ETON America, LLC

Service Bulletin

Bulletin No:	0036
Date:	01/06/06

RX4-90R Not shifting properly, shift motor making noise, or indicator lights blinking.

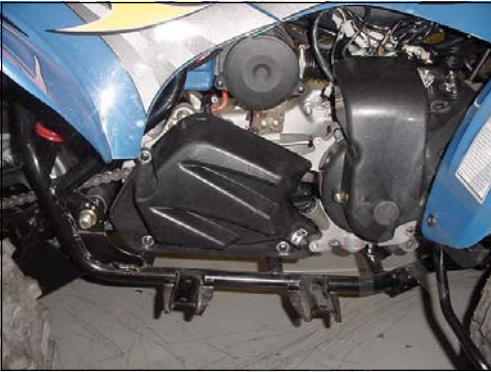
There is an engineering change affecting the 2006 Viper 90R 4 cycle ATV with Engine Numbers below JIExxxxxxxxx751. The Shift Push block has been reengineered to reduce friction, allowing the shifting motor to complete the shift process. Units with out this upgrade may display some or all of the following symptoms:

1. Incomplete shifting causing blinking indicator lights
2. Grinding noise from shift motor
3. Engine stalling during shifting
4. Starter motor reduction gear failure

Qty	Part No.	Description
1	811674	Shift Push Assembly
